CITY OF MANZANITA Manzanita Classic Street Connection Project Addendum Number 2

DATE: May 7, 2025

ENGINEERING PLANS - ADDENDUM 2

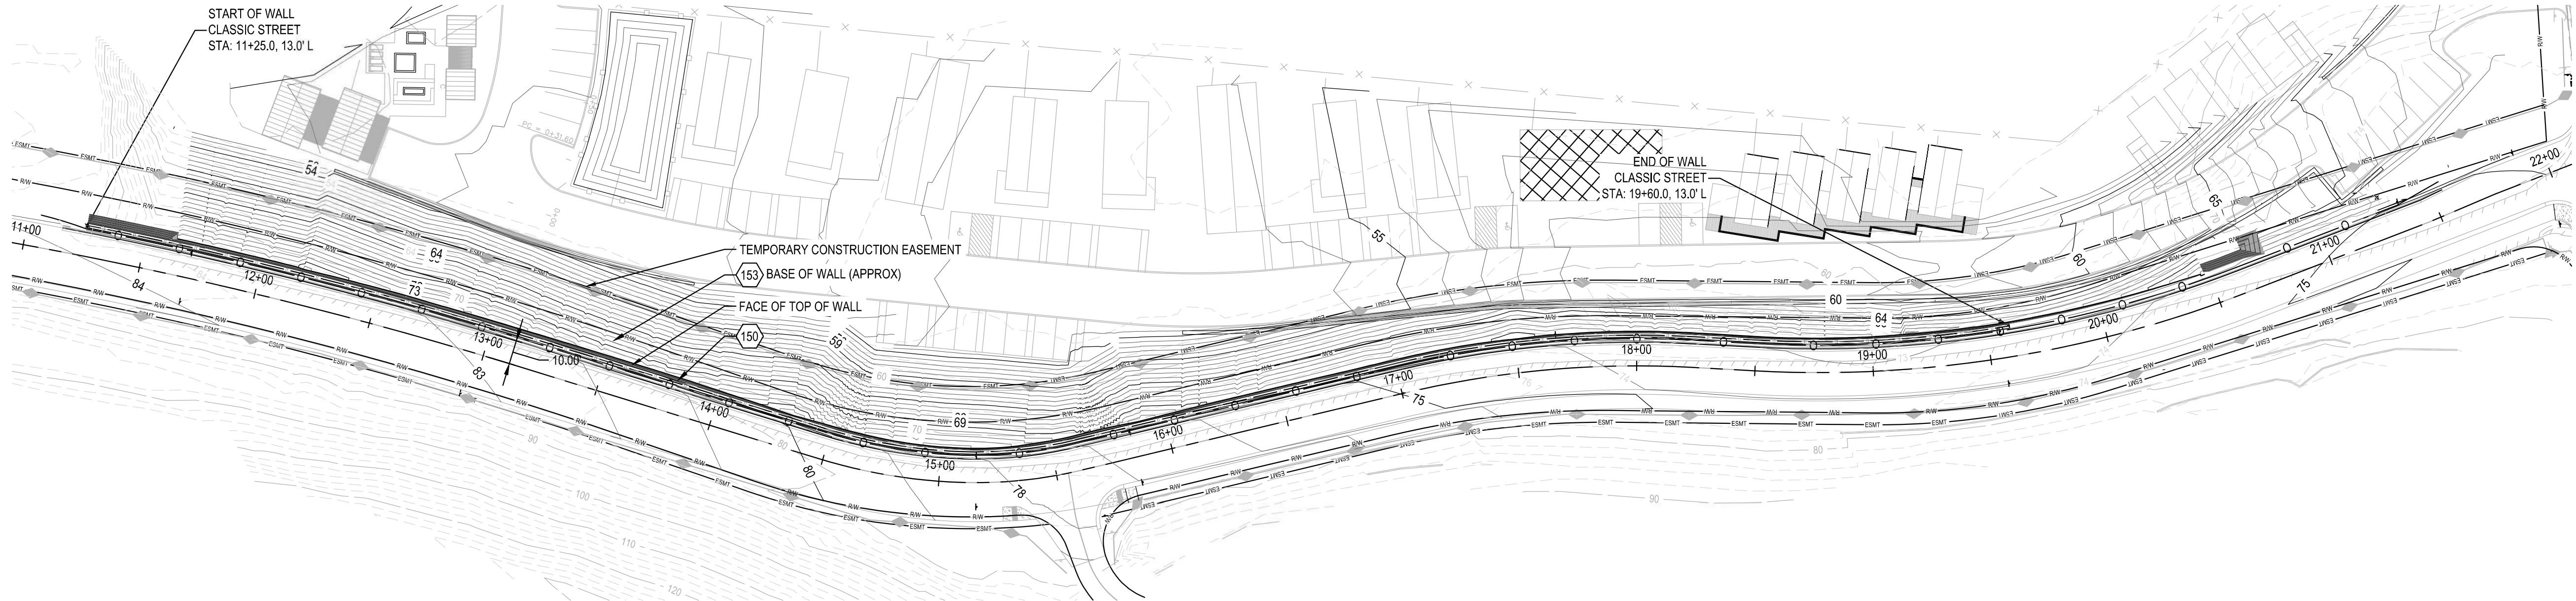
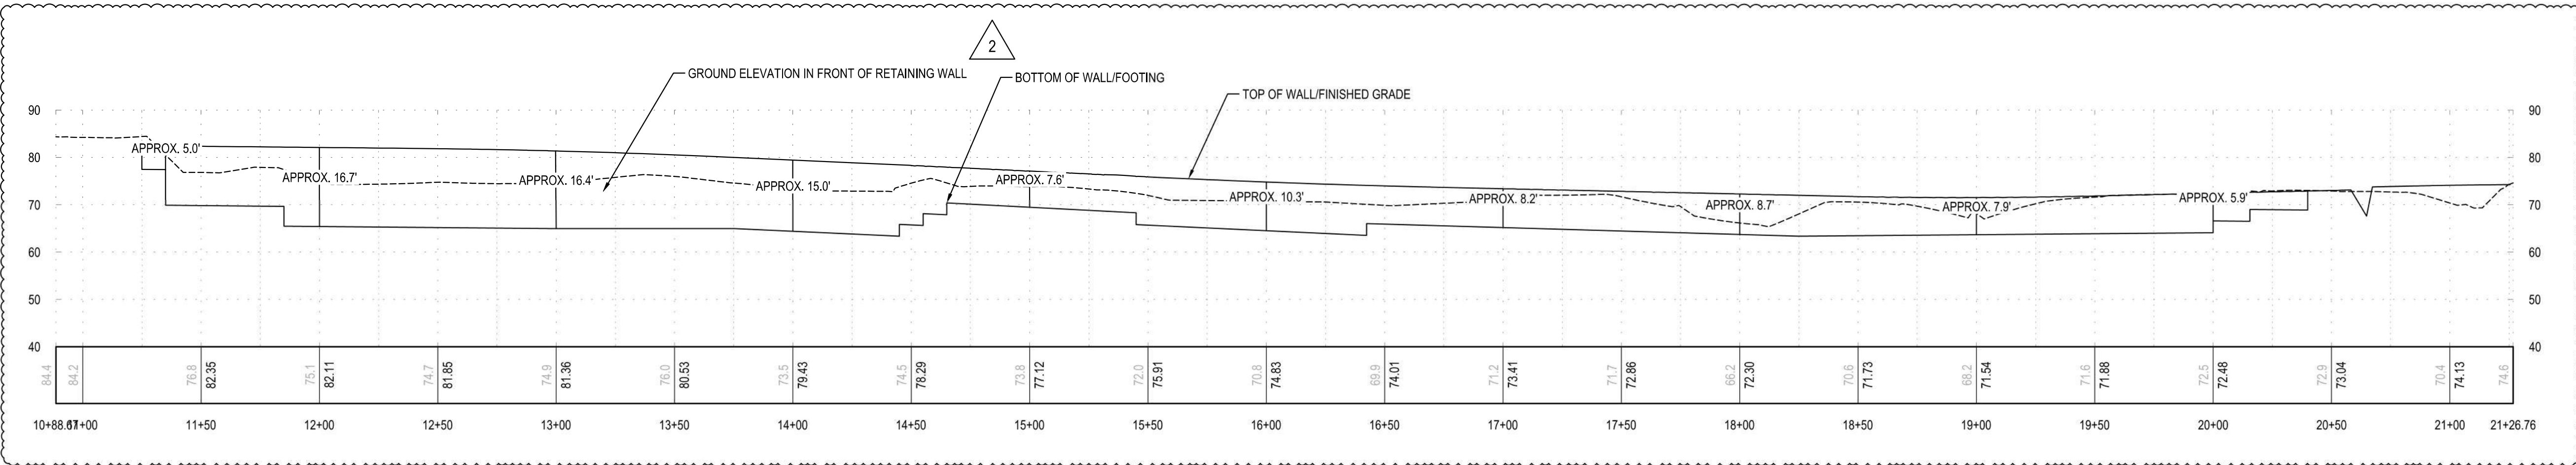
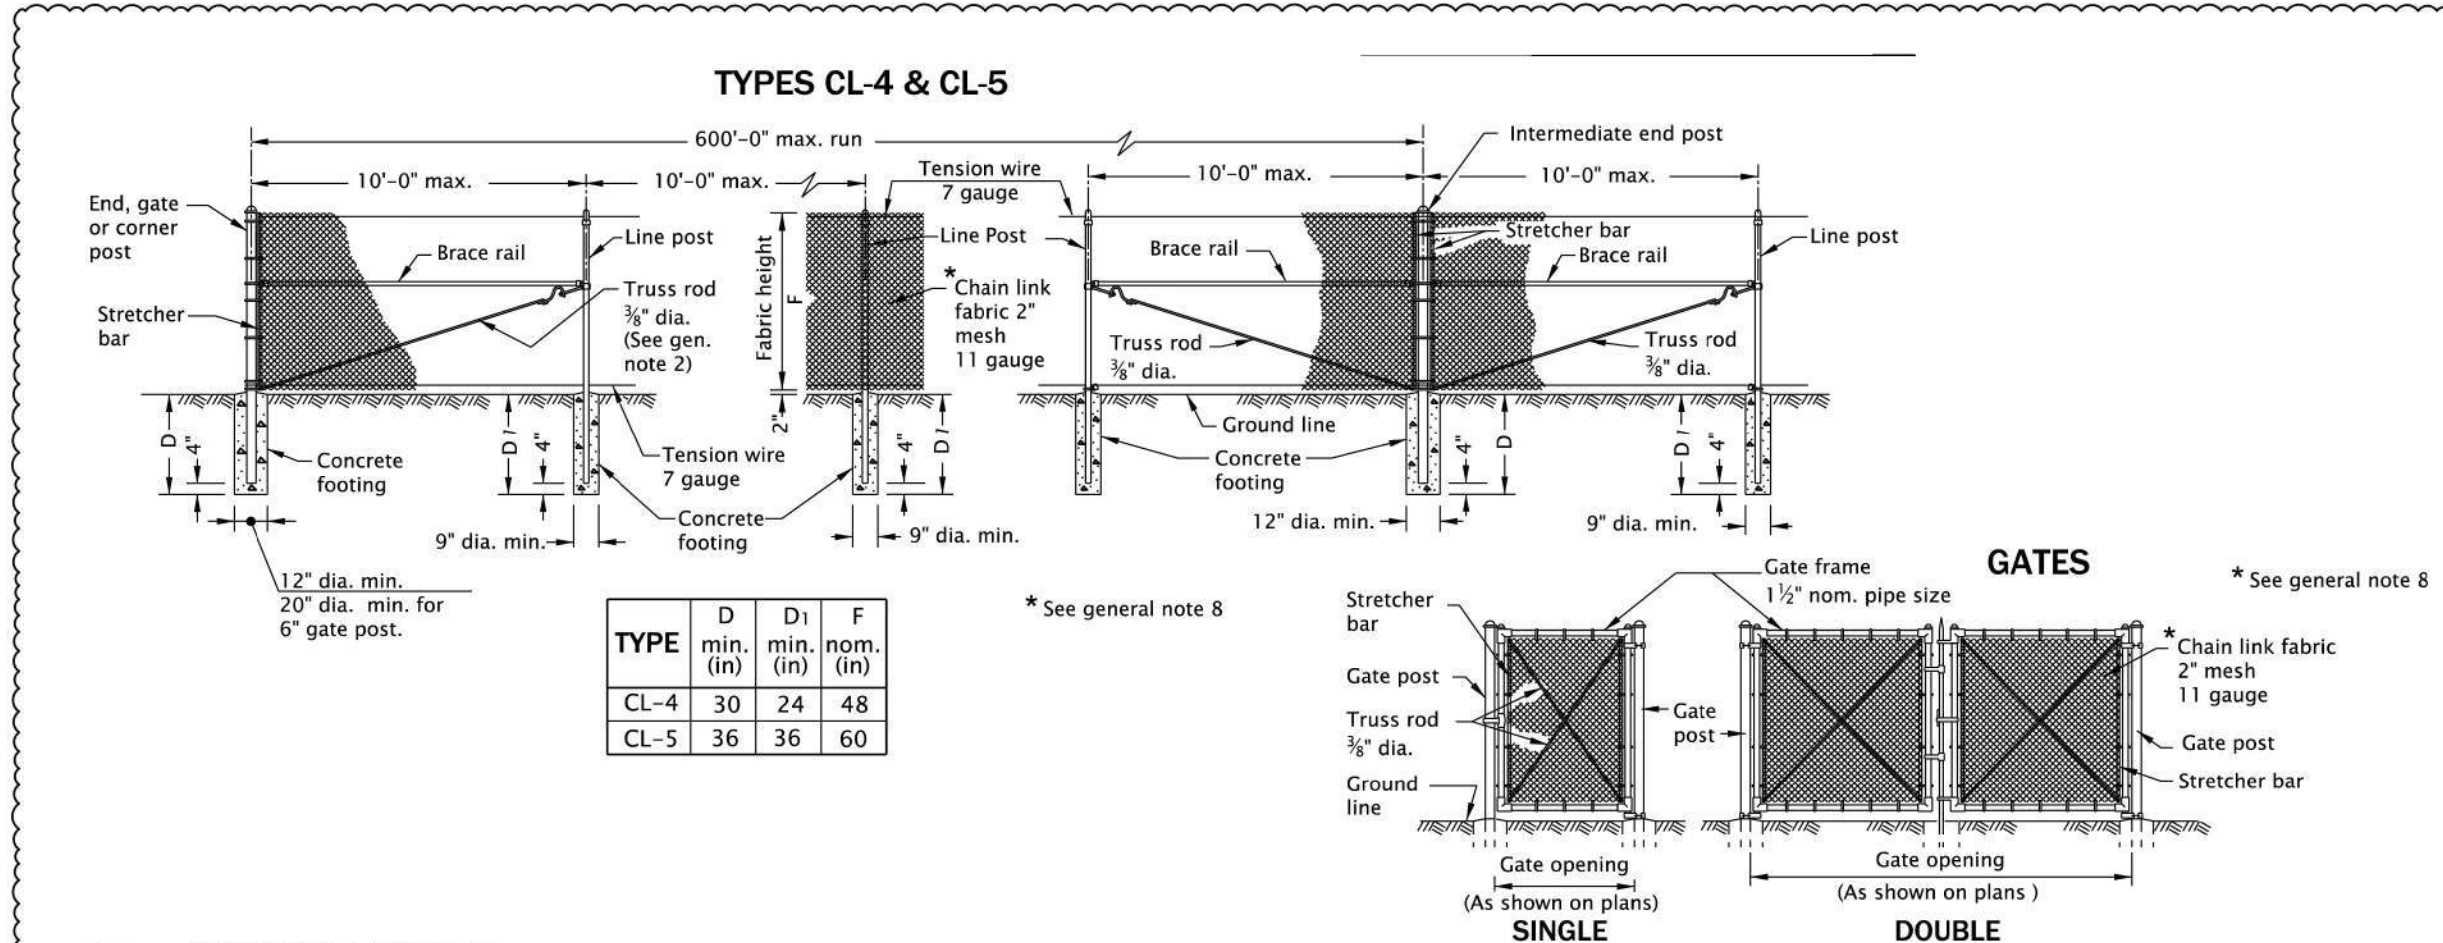
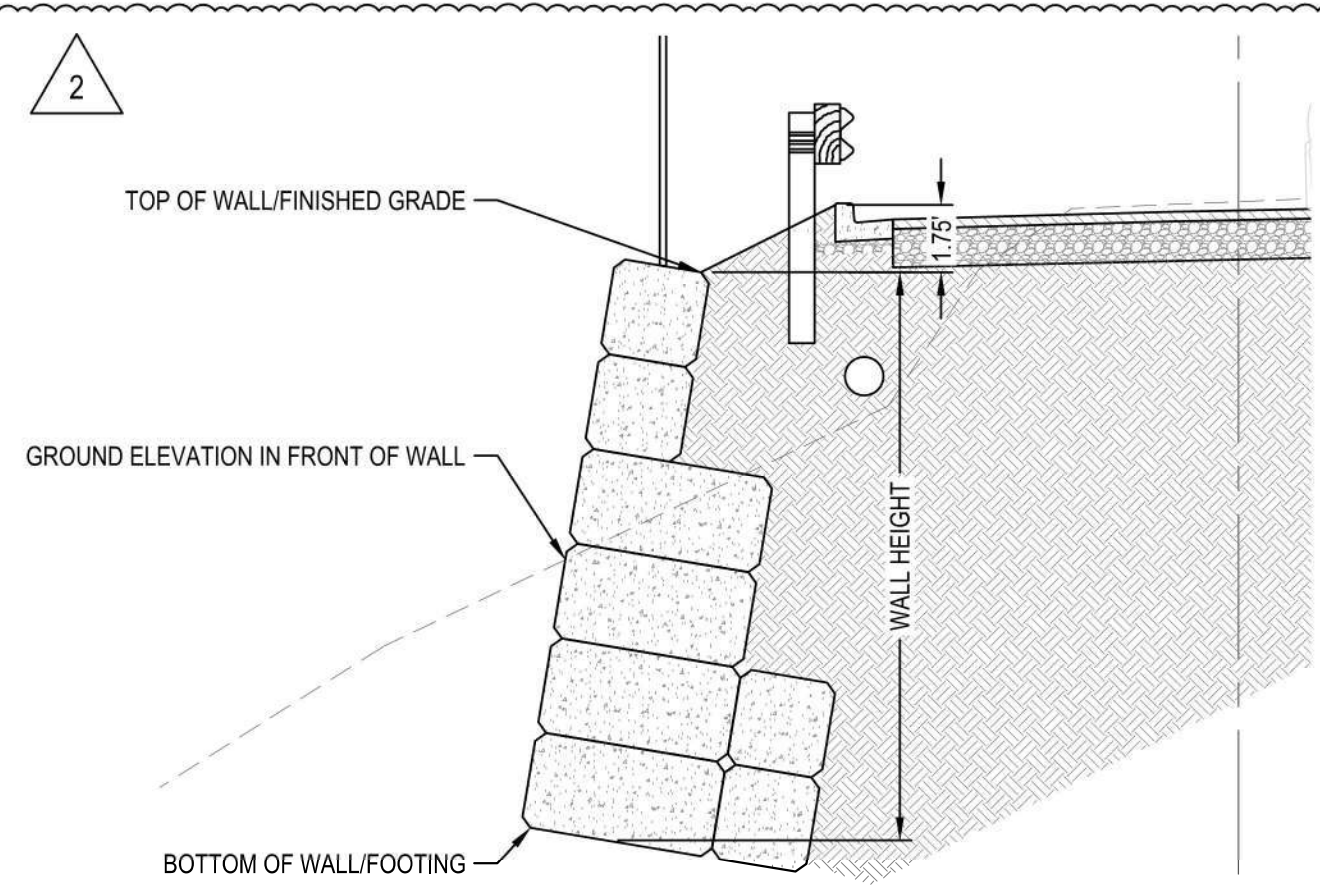
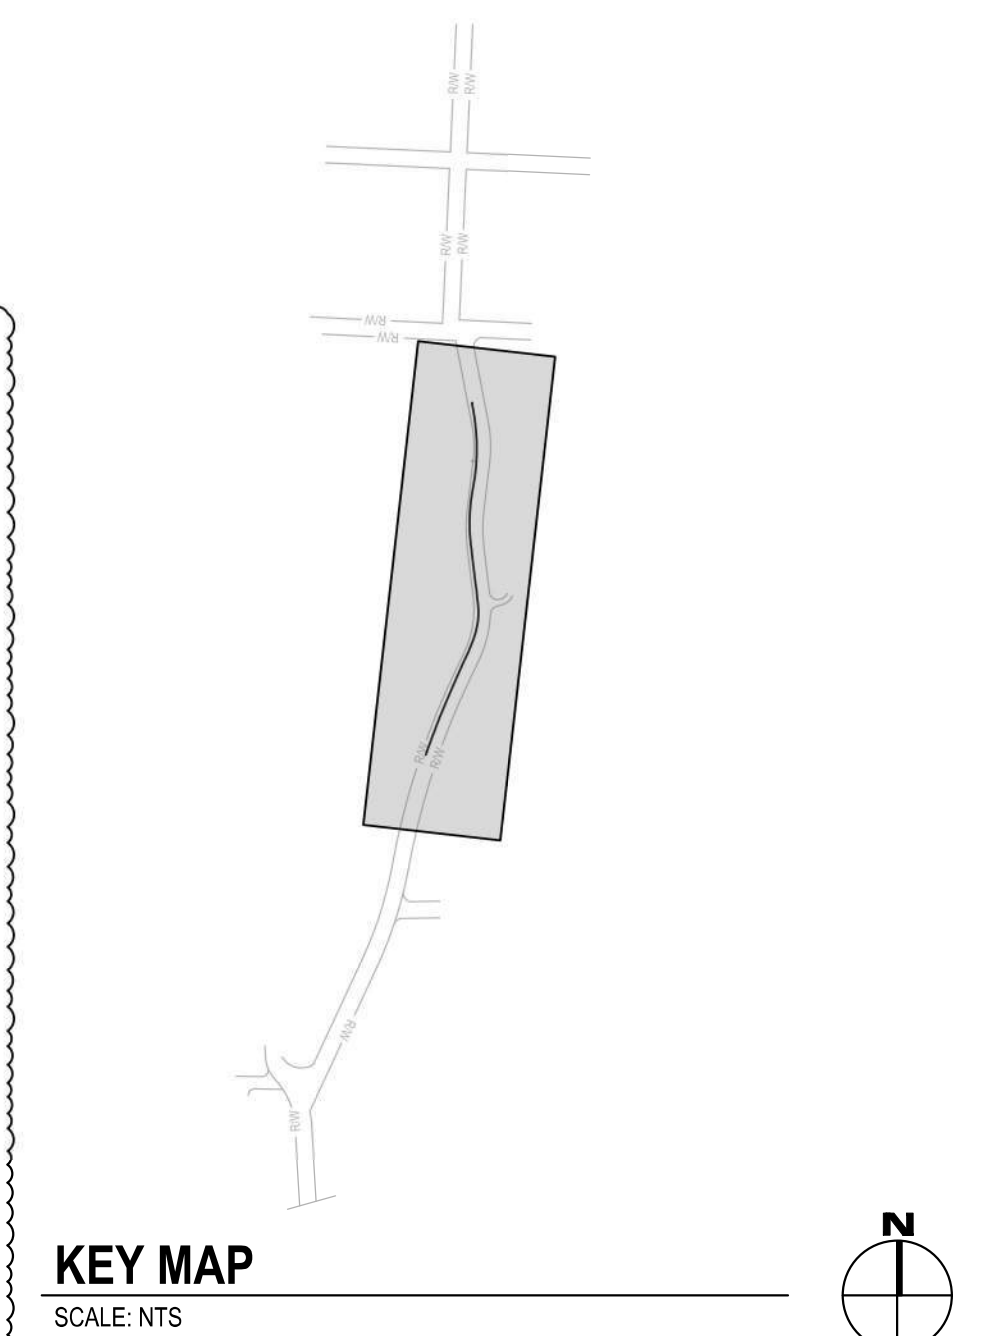
- a. **The 22' average height was based on the initial engineered design, measured from the bottom of a footing to the top of the wall. The wall profiles will be (Sheet C600) the controlling design parameter. Additional plan information is provided with this addendum. AutoCAD developed elevation and contour information will be available on the QuestCDN site attached to Addendum 2 information.**

- NOTE: The final wall height should be determined by the contractors' deferred design based on the recommendations in the geotechnical report.**
- b. **The wall profiles in the plan sheets are estimated based on Pali's Geotech report. They show existing grade and proposed wall heights based on the initial wall selection and recommendations of the geotech.**

- **C600** – Retaining Wall Plan: Proposed contours updated to include development proposed contours to show how grading tie-ins work along the retaining wall, approximately from Sta 11+00 to 22+00. Call outs for “Temporary Construction Easement” and “Permanent Easement” have been added. Added a cross-section to help explain the ground elevations shown in the profile better.
